MEMORANDUM

To: All Holders of the Virginia Department of Transportation's 2001 Road and Bridge Standards

The following is a list of revised standards contained in the 2001 Road and Bridge Standards that have a revision date of 7/01. These pages replace the previously issued pages in your copy of the standards. An insertable sheet will not be required in plan assemblies.

REV. 7/01
 102.01

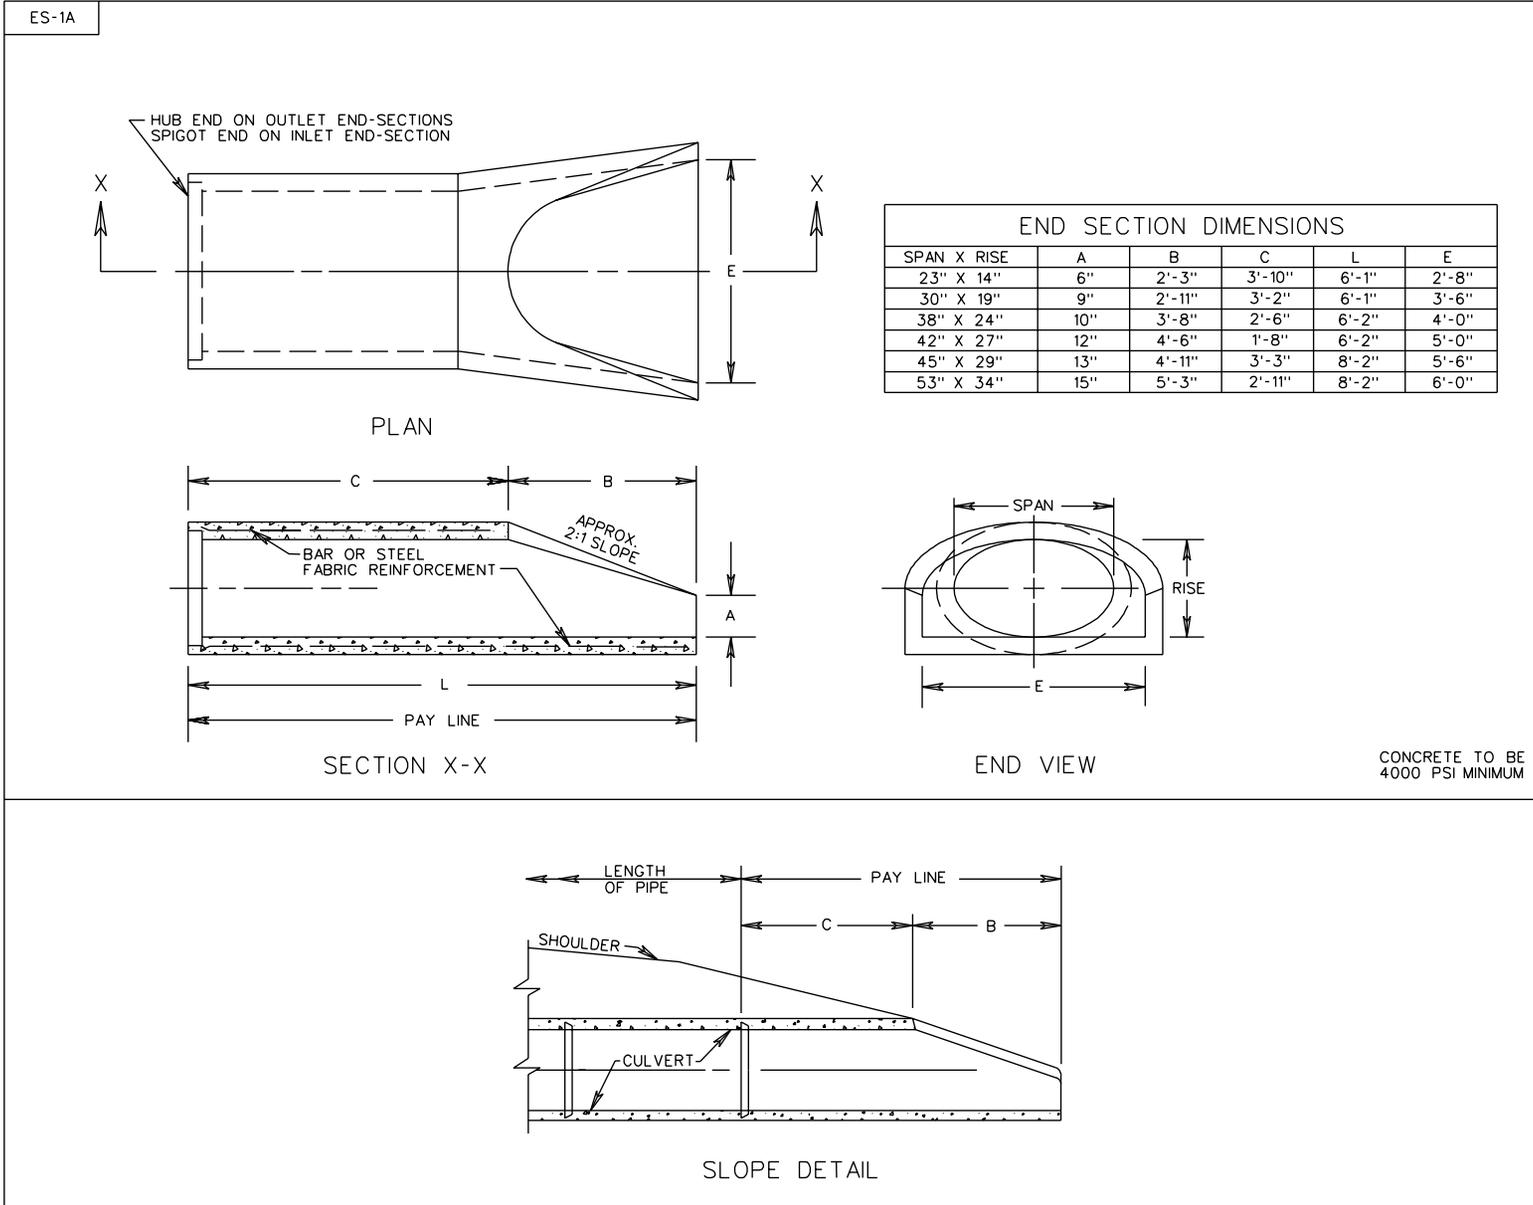
STANDARD	PAGE	REVISION
ES-1 (A142)	102.01	Revised length of pipe dimension.
ES-1A (A130)	102.02	Revised length of pipe dimension.
ES-2 (A142)	102.03	Revised length of pipe and pay line dimensions.
DI-10J, K, L (A100)	104.29	Added Note 25.
DI-14D, E, F (A102)	104.40 104.41	Corrected Note 1. Deleted Note 15 and renumbered remaining notes. Added new Note 25 (IS- 1 shaping).
EC-6 (isd 414_2)	114.07	Deleted Note 1 and renumbered remaining notes.
CG-12A (A59)	203.05	Revised slope dimension in Section A-A.
GR-6 (A132)	501.09 501.10	Revised maximum ditch fore slope. Revised end anchorage. Revised anchor bolt size for rock cut installations.
GR-8A, B, C (A91)	501.14 501.15	Revised to meet NCHRP 350 Test Level 3 Test Criteria.
GR-FOA-1 (A65_1 & A65_2)	501.25 501.26 501.27	Revised to meet NCHRP 350 Test Level 3 Test Criteria.
GR-FOA-2 (A66_1 & A66_2)	501.28 501.29 501.30	Revised to meet NCHRP 350 Test Level 3 Test Criteria.

REV. 7/01
501.34

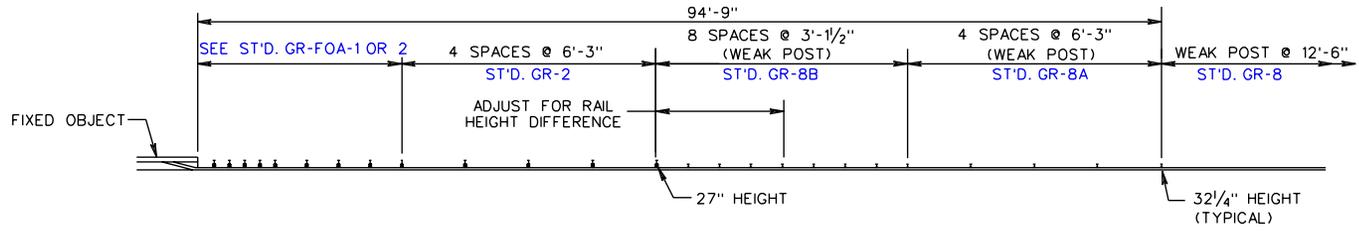
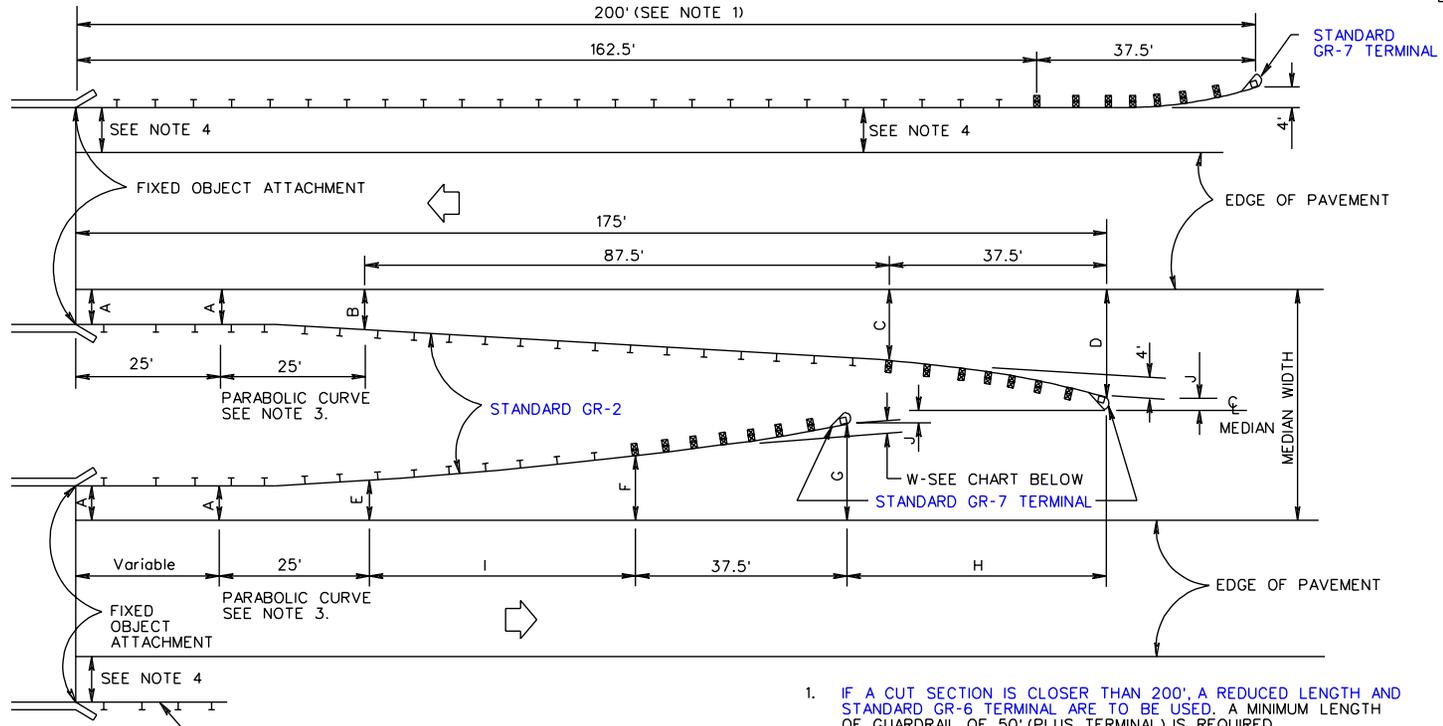
STANDARD	PAGE	REVISION
EW-7S	101.19	Corrected the concrete quantity for 42" Dia. concrete pipe with a 2:1 fill slope.
DI-3D, E, F	104.12	Revised the 2'-0" Utility Space dimension in the Plan View.
MH-1	106.01	Revised Note 7.
PC-1, Sheet 1 of 17	107.05	Revised minimum heights of cover note.
PC-1, Sheet 16 of 17	107.20	Added 42" and 48" diameter polyethylene pipes.
SB-1	110.01	Revised pipe size and material. Added note.
SB-1 PC	110.02	Revised pipe size and material. Revised Pipe Connection detail. Added pipe connection note.
MS-1A	202.03	Added depth of curb dimension to Alternative With Extruded Curb detail.
CG-11	203.04	Deleted CG-12 detail from Plan View. Revised 4' sidewalk dimension.
RW-3	401.02	Corrected formula for base thickness in table.
GR-2, 2A	501.05	Deleted duplicate blockout thickness dimension in Steel Post detail.
GR-SP	501.16 501.17	Deleted Note 4. Revised Note 4 and deleted Note 6.
GR-INS, Sheet 2 of 8	501.34	Corrected B and C dimensions for 40' median width.

501.39

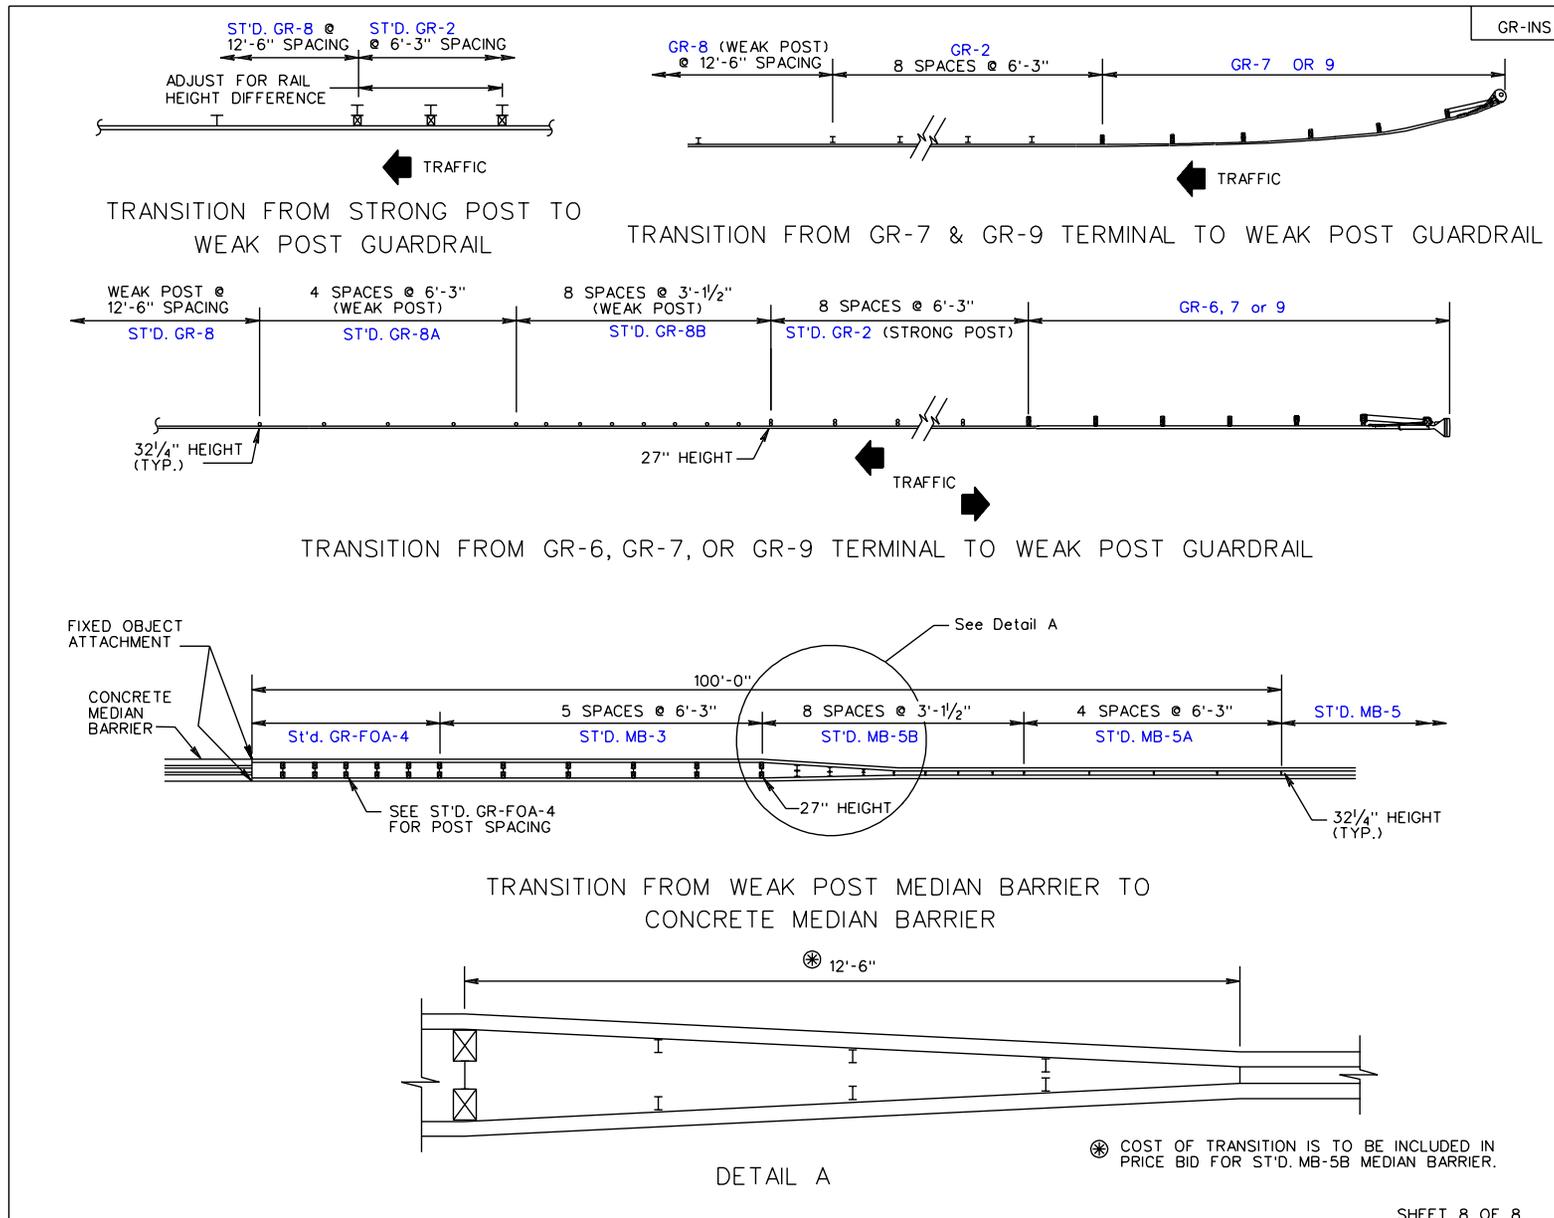
STANDARD	PAGE	REVISION
GR-INS, Sheet 7 of 8 (A93)	501.39	Revised GR-8 guardrail height.
GR-INS, Sheet 8 of 8 (A93)	501.40	Revised GR-8/MB-5 guardrail heights.
MB-5 (A95)	501.42	Revised to meet NCHRP 350 Test Level 3 Test Criteria.
JB-1B, 2B, 3B, 4B, 5B (A140)	1301.50	Revised concrete collar thickness.
JB-1C, 2C, 3C, 4C, 5C (A141)	1301.51	Revised concrete collar thickness.
